From: Jeff Lehman
Sent: Thursday, October 7, 2021 5:29 PM
To: Hans Hunger; Ken Cook; Mark Higginson; Bryan Roberts; Sarkany, Rick; Ken Lee; Cooney, Steve (Contractor); Russell, Brian (Contractor); Farrell, Robin (Contractor) (c-Robin.Farrell@soundtransit.org); Yilin Wang (yilin.wang@concordengr.com); Syed Rahman; Justin Matthews; Brent Pilon; Shimizu, Greg; Ken Davies; Cary Bertram; Greg Edwards
Cc: Jeff Lehman
Subject: E-21-0022/ST Parking Garage - 4th/Stewart Signal Cabinet Concept Discussion - Notes/Exhibits for Reference
Attachments: 4th & Stewart Cabinet Relocation Concept Design_09292021.pdf; 4th & Stewart Cabinet Relocation Conduit Fill Calculation_09292021.pdf; 5th St NW Curb-Lane Adjustment-CONCEPT.pdf
Importance: High

I am following up on our 4th/Stewart Signal Cabinet discussion today with the City of Puyallup (City), Sound Transit (ST) and Hensel Phelps (HP) Team. Attached are the (3) documents reviewed in today's discussion, including: 1) Concept Design of 4th/Stewart Signal Cab Shift, 2) Conduit Fills for Temp and Proposed/Final condition of existing W Stewart conduit crossing and 3) 5th St NW curb/lane adjustment.

PUYALLUP STATION PARKING
 CONTRACT RTA/CN 0612-18

DRAWING No.: **F1592-TSP201**
 FACILITY ID: F1592
 SHEET No.: REV:

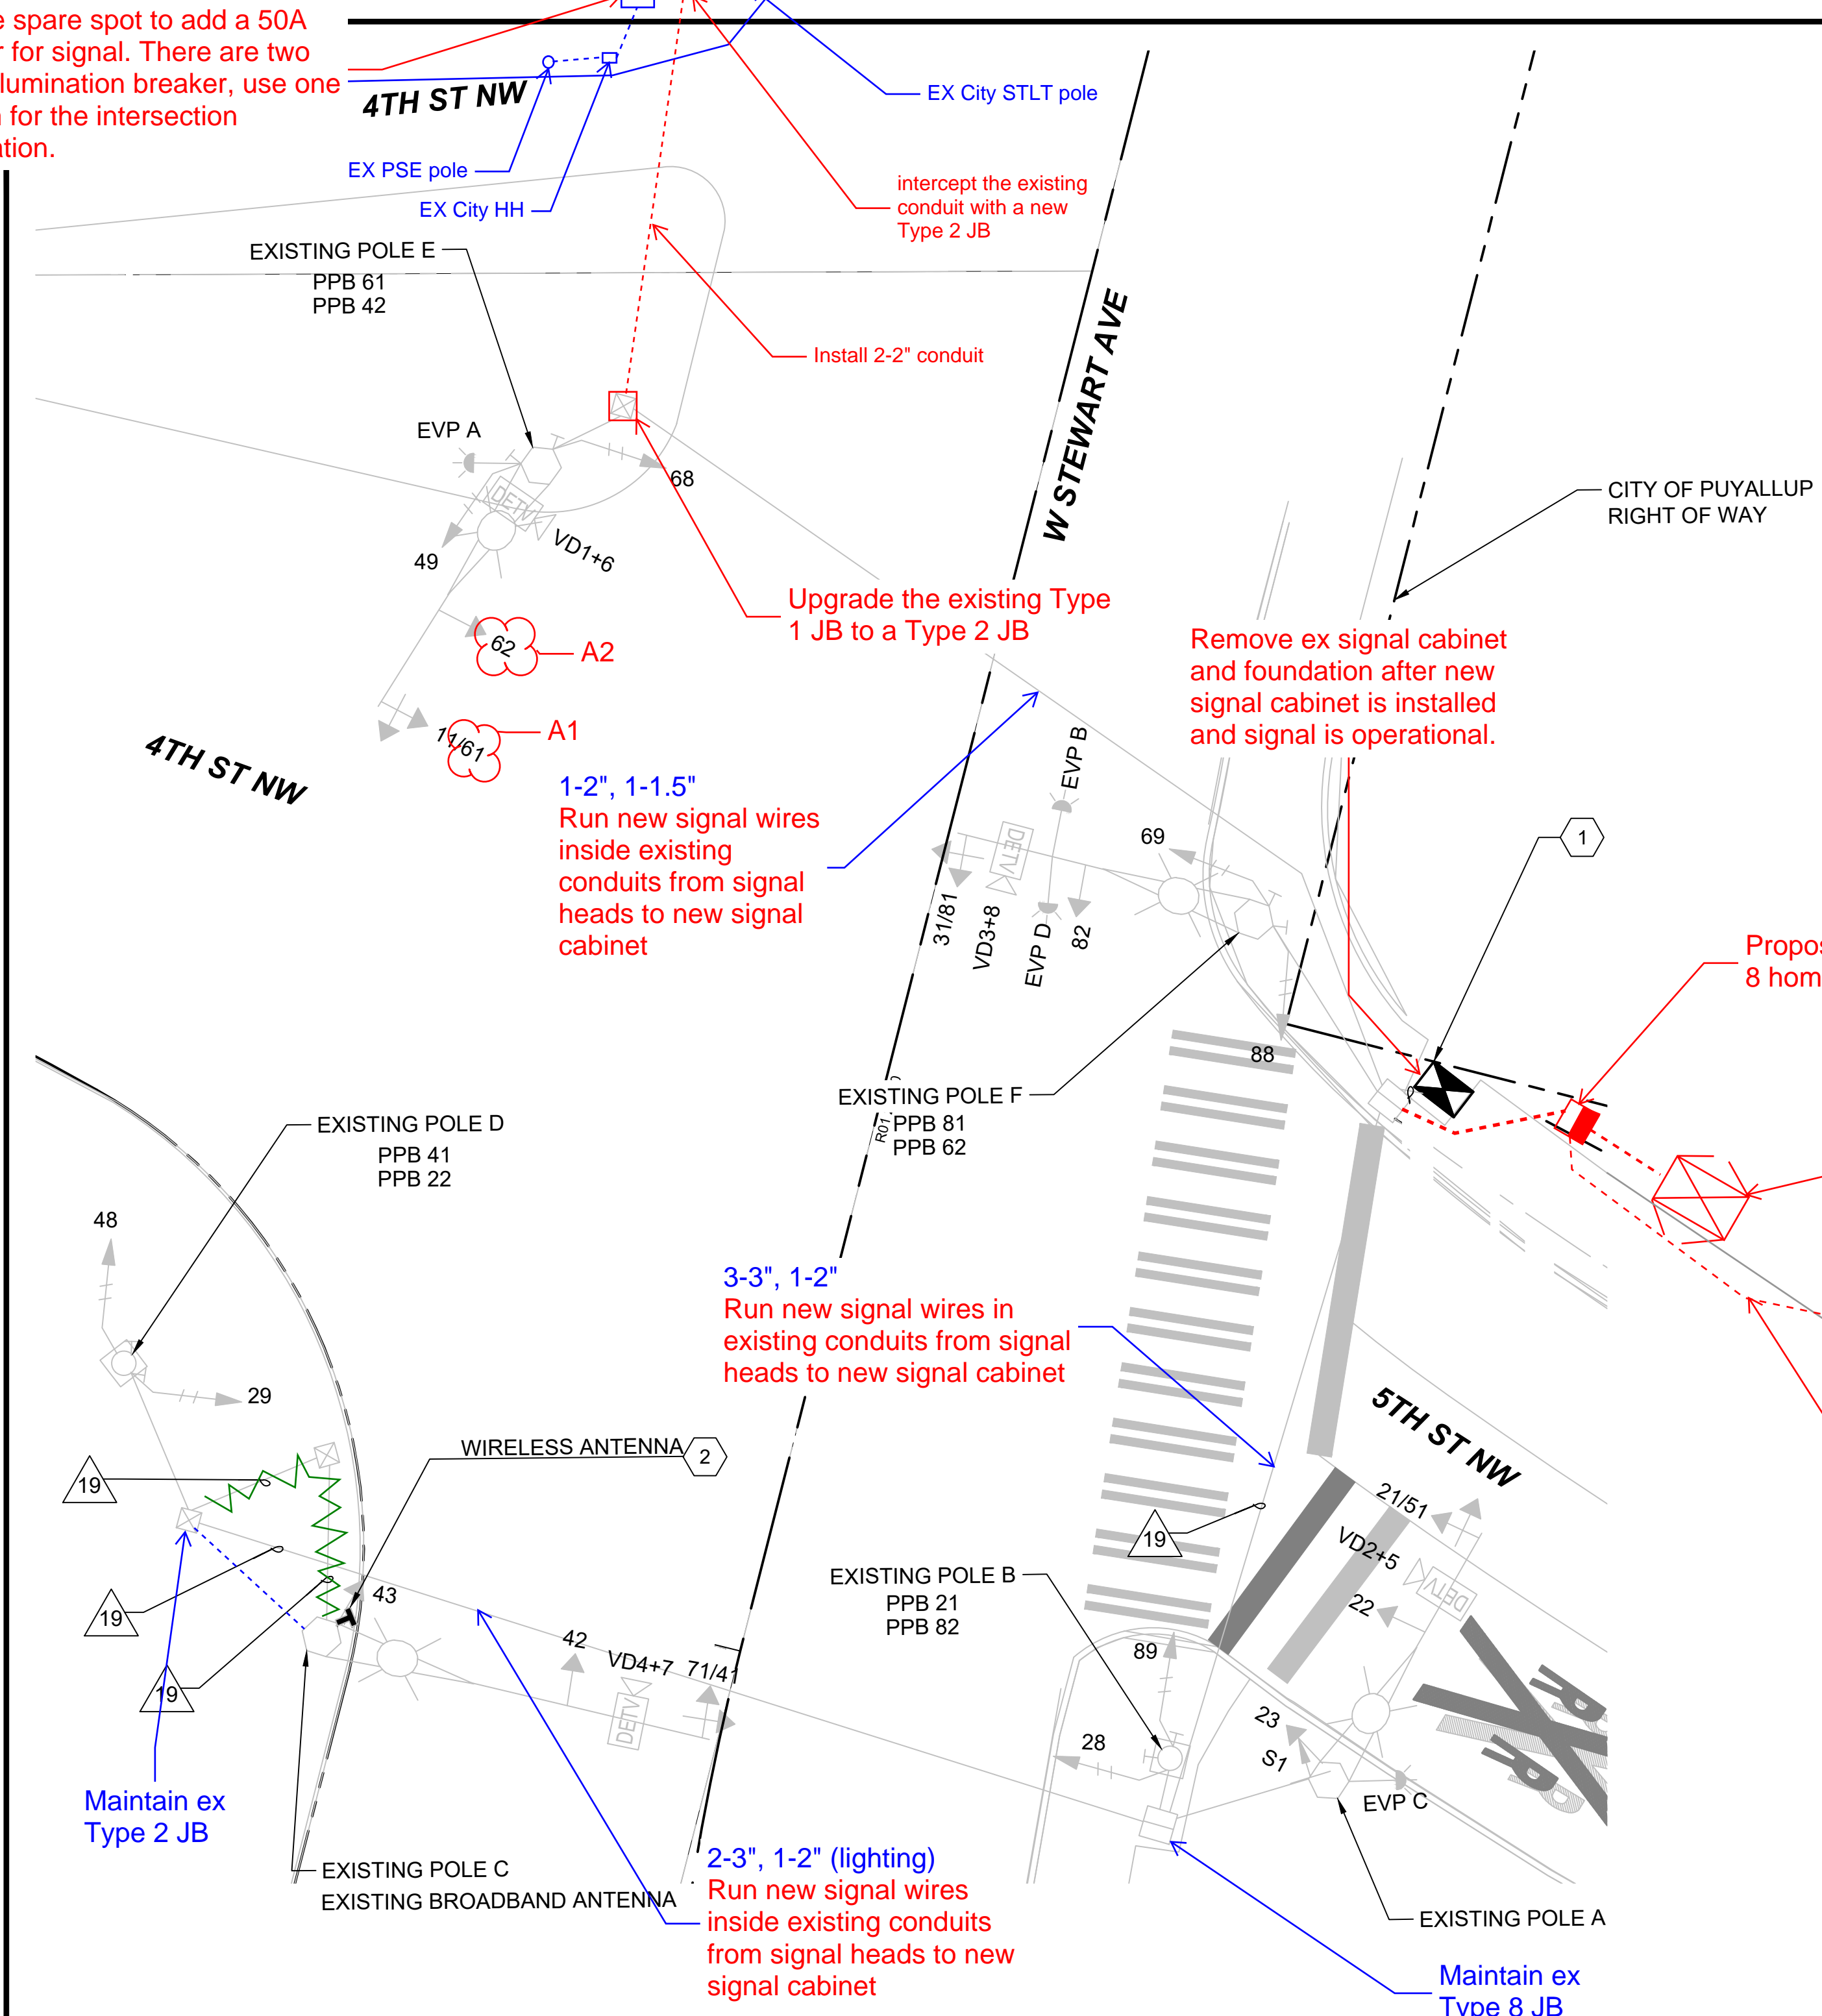
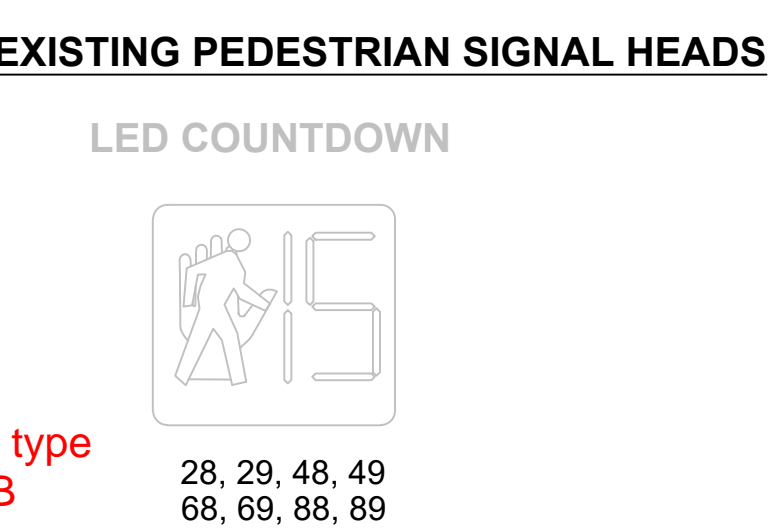
EX service cabinet.
 Use the spare spot to add a 50A breaker for signal. There are two spare illumination breaker, use one of them for the intersection illumination.

Update proposed phase diagram - add overlap phasing for NB pre-signal operations

Propose new type 8 homerun JB

Propose a new 350i ATC cabinet outside the sidewalk, within the City's ROW approx. 10 ft from the original location. BBS inside the cabinet, terminations at the backside of the cabinet. Give 8ft clearance for sidewalk.

New conduit for pre-signal and RR preemption

1. Use 5C signal cables
2. Use 3C for pedestrian signal cables
3. New conduit for pre-signal and RR preemption wires connects to the new homerun JB, not the existing homerun JB.
4. Need to work with Rhythm Engineering to make sure the adaptive signal equipment will be configured with the new signal cabinet.
5. Conduits crossing east leg are RGS conduits. They might rust already which may have issues when pulling cables.

**PUYALLUP STATION PARKING
 CONTRACT RTA/CN 0612-18
 INTERSECTION EXHIBIT**

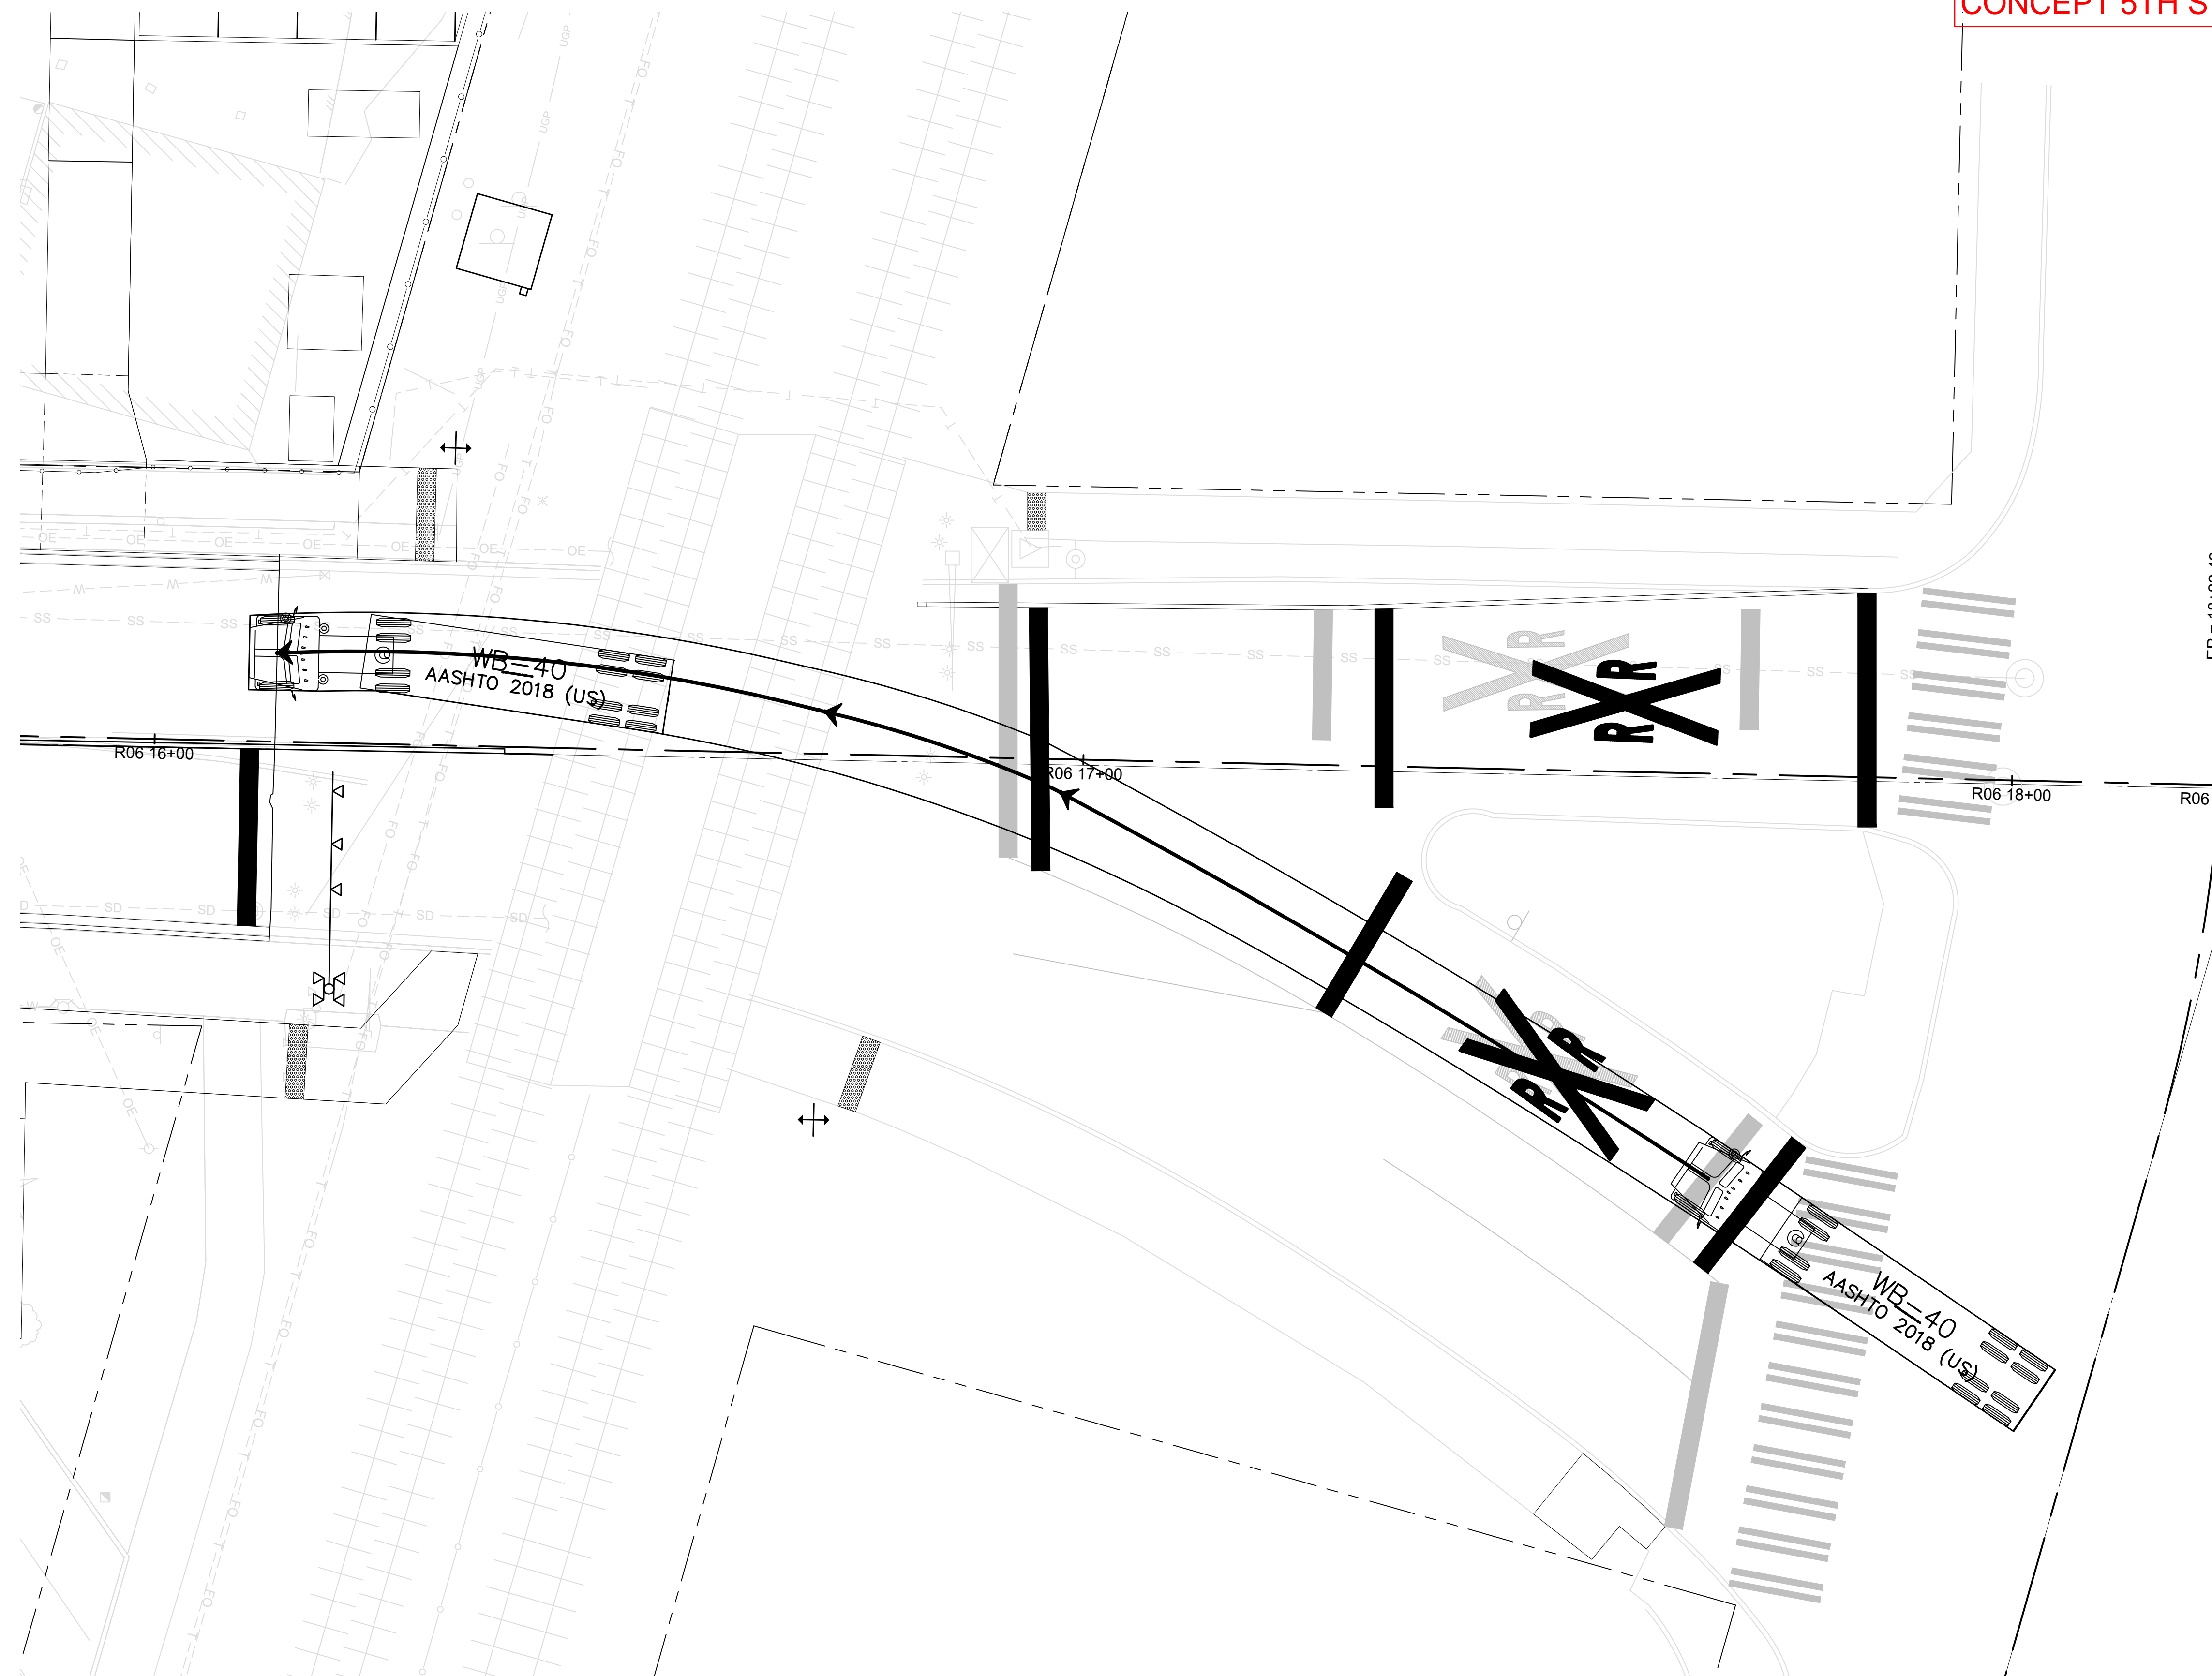
- **5th St NW Curb/Lane Adjustment:**
 - Group reviewed the proposed curb/lane adjustments along west side of 5th St NW – This modification is in response to request from BNSF to meet their current standards
 - City confirmed no initial concerns with the proposed curb/lane adjustments, but will review and provide any initial comments prior to the preparation of formal Plan Change Request document submittal
 - City requested restoration with Curb/Gutter at HMA roadway section and then doweled curb at Concrete roadway section
- **4th Stewart Concept Design:**
 - Group reviewed the proposed 4th/Stewart Signal Cabinet relocation concept and the Temporary and Proposed/Final conduit fills for the W Stewart conduit crossing.
 - Specific to Conduits and Conduit Fill Calculations items discussed:
